MALLORY SONALERT PRODUCTS, INC.

Number: 20005

### PRODUCT CHANGE NOTIFICATION

ALL LSC SERIES ALARMS ( LSC110N / LSC110NR / LSC250N / LSC250NR / LSC616N / LSC616NR / LSC628AN / LSC628ANR

**LSC250N**

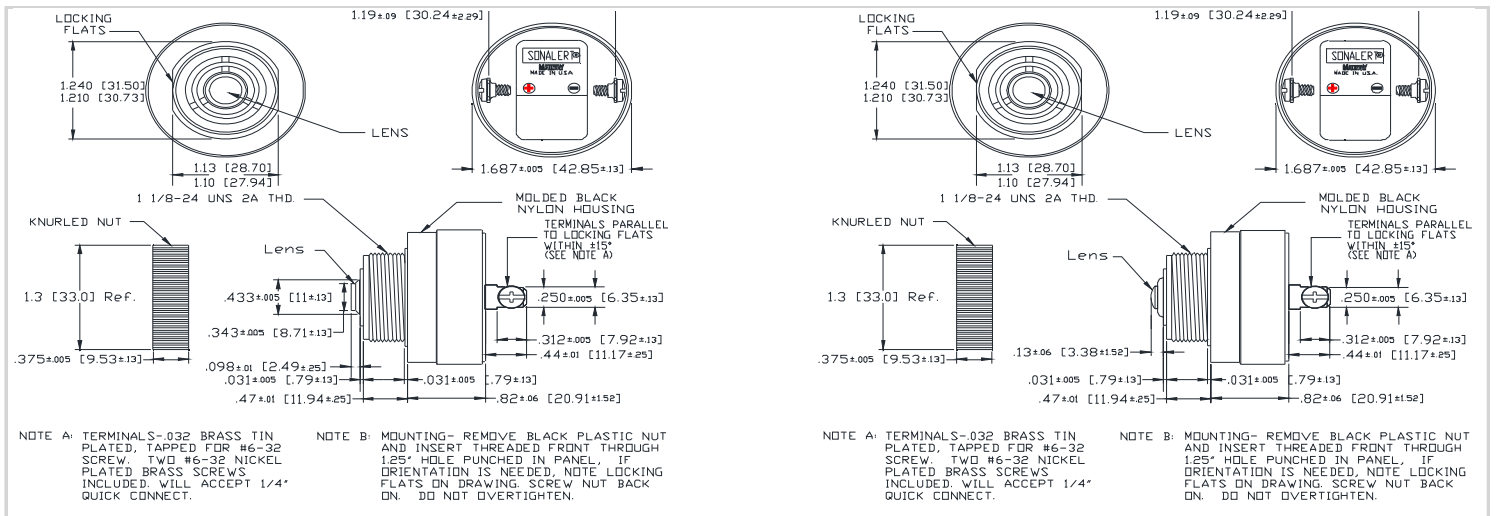
Before Code Date: 2017 1

After Code Date: 2017 1

**LSC110N**

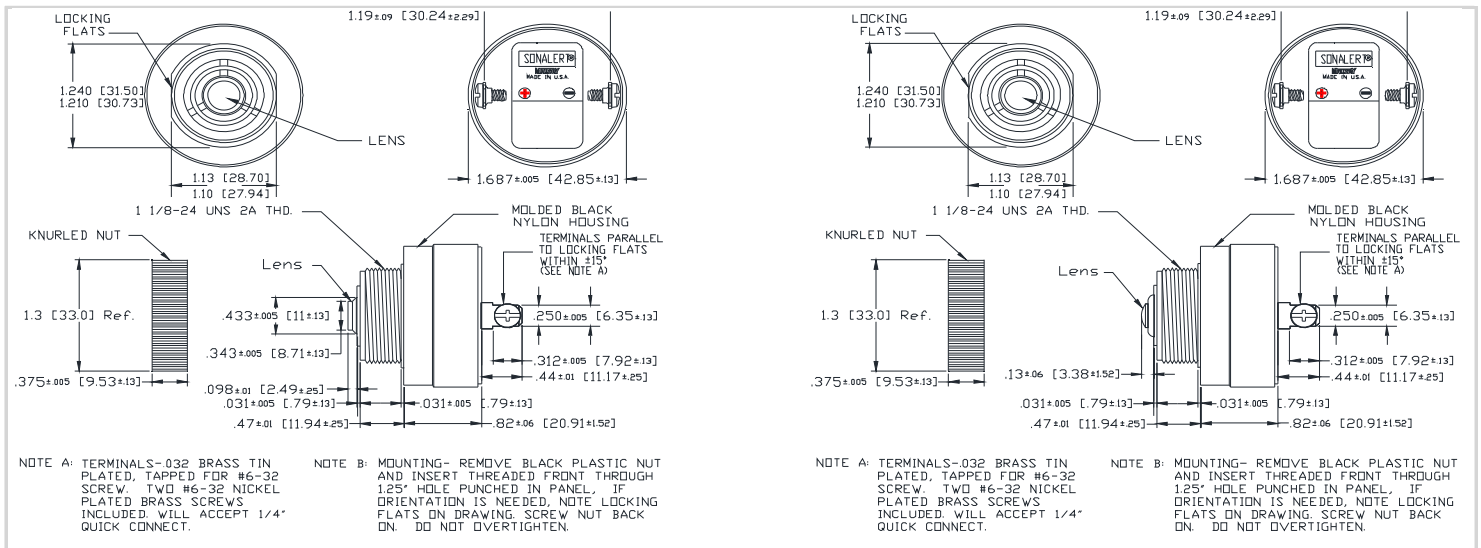
Before Code Date: 2018 5

After Code Date: 2019 1

**LSC616N**

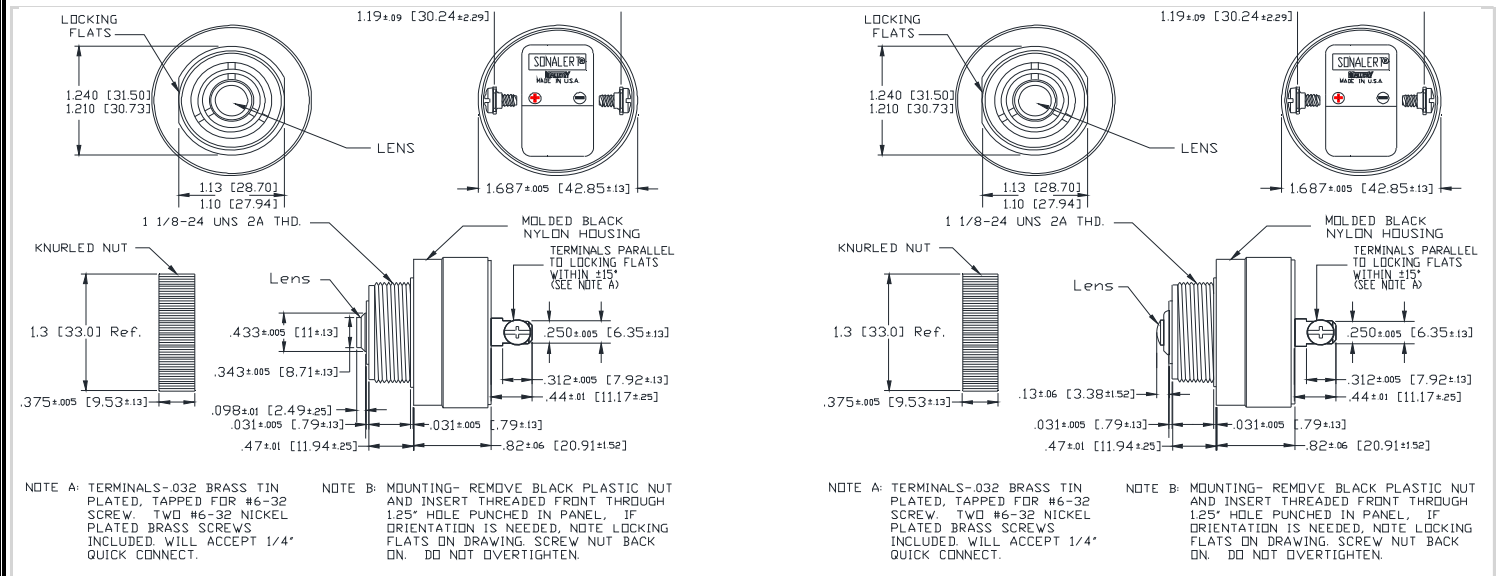
Before Code Date: 2018 5

After Code Date: 2019 1

**LSC110NR**

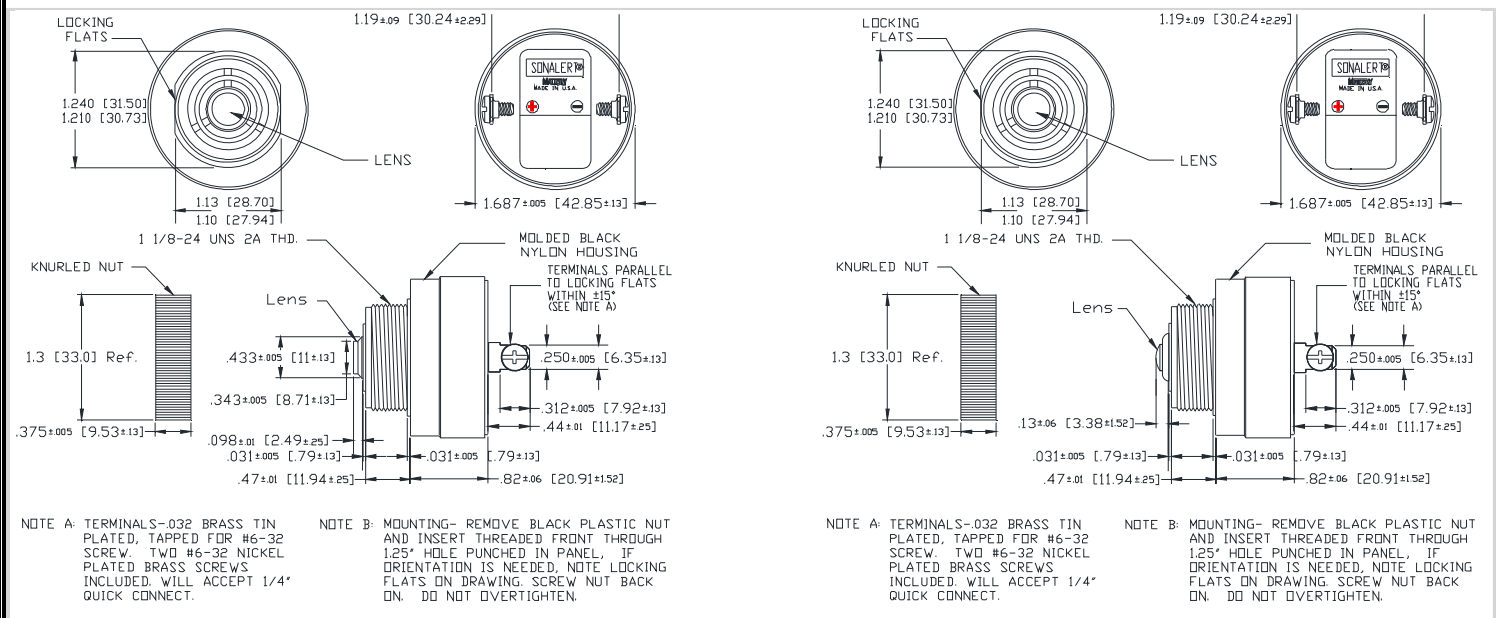
Before Code Date: 2018 5

After Code Date: 2019 1

**LSC628AN**

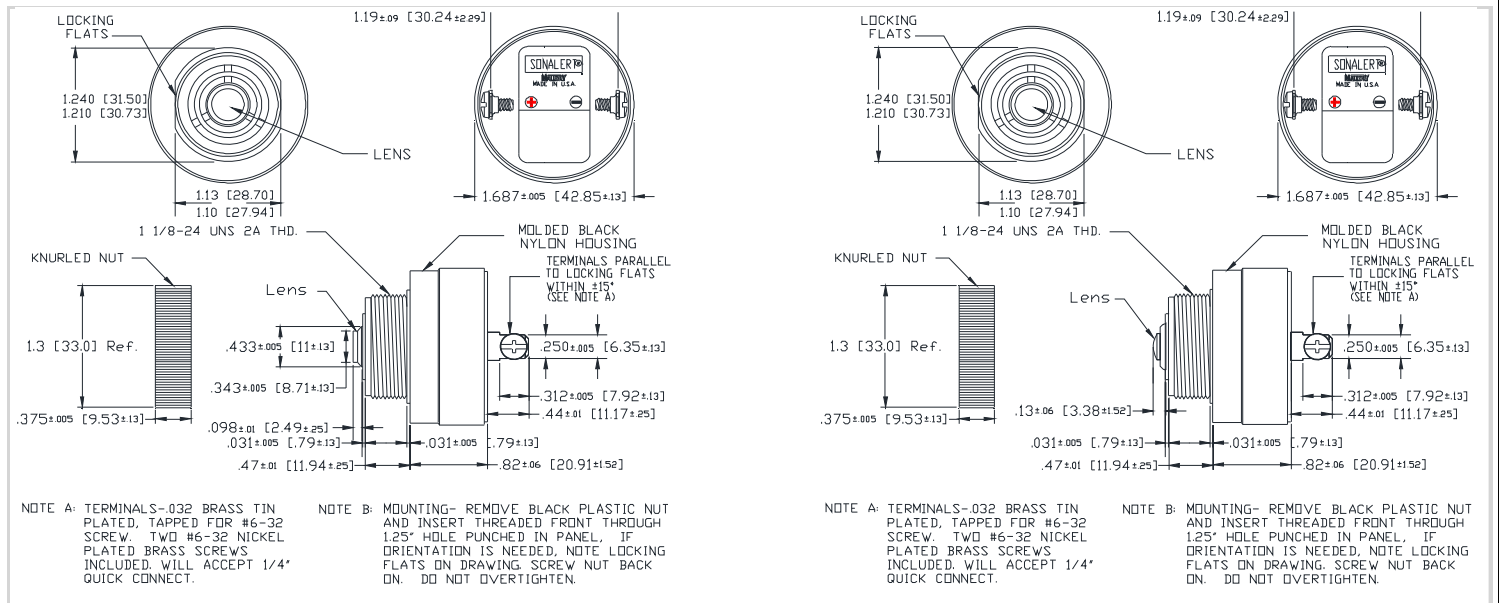
Before Code Date: 2019 5

After Code Date: 2020 1

**LSC250NR**

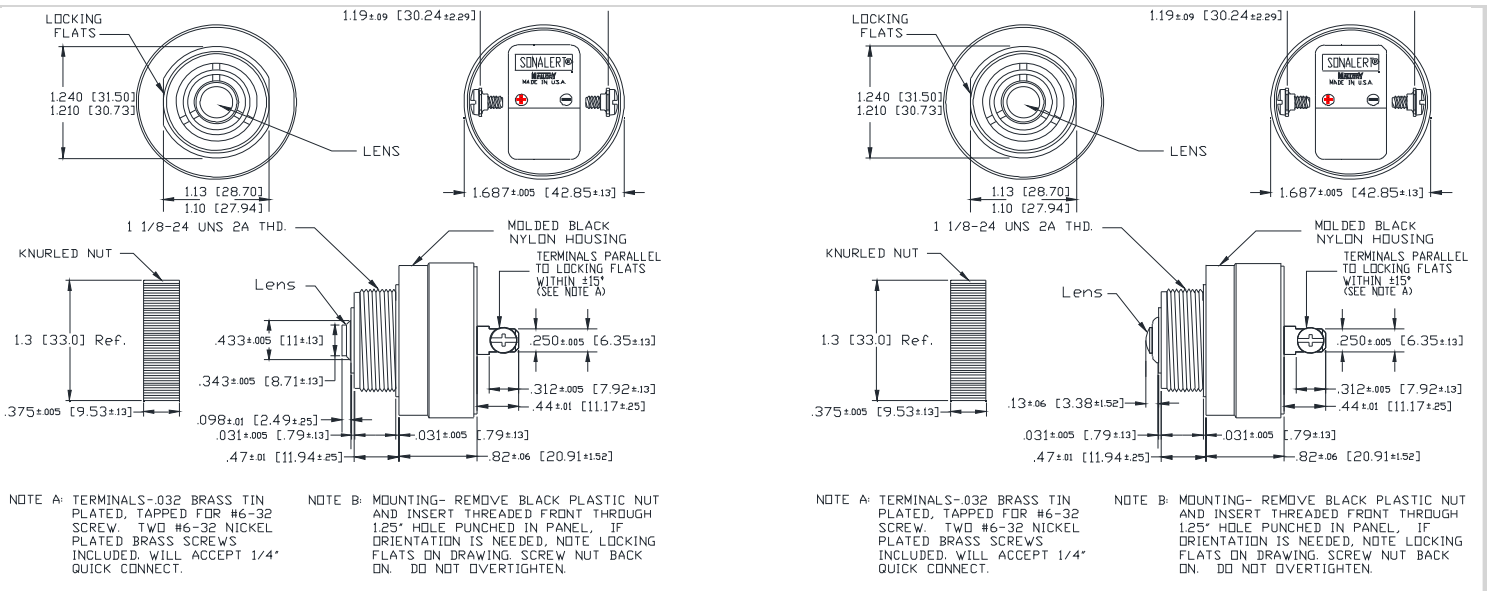
Before Code Date: 2018 5

After Code Date: 2019 1

**LSC616NR**

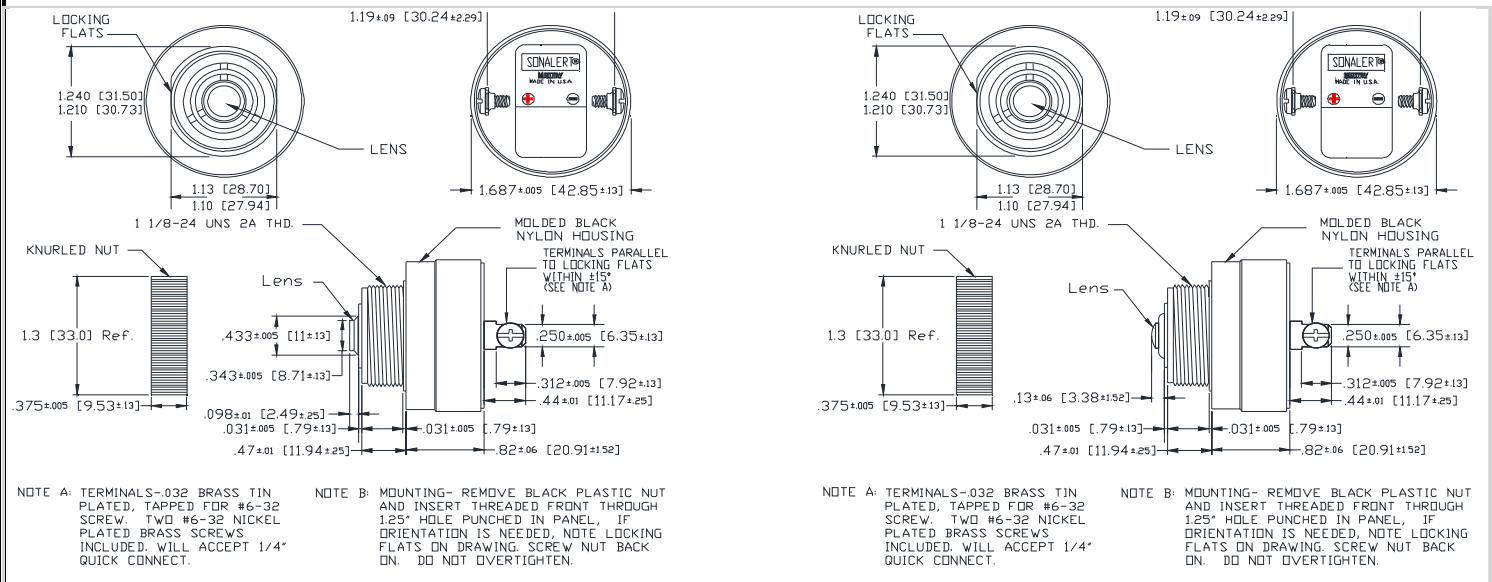
Before Code Date: 2018 5

After Code Date: 2019 1
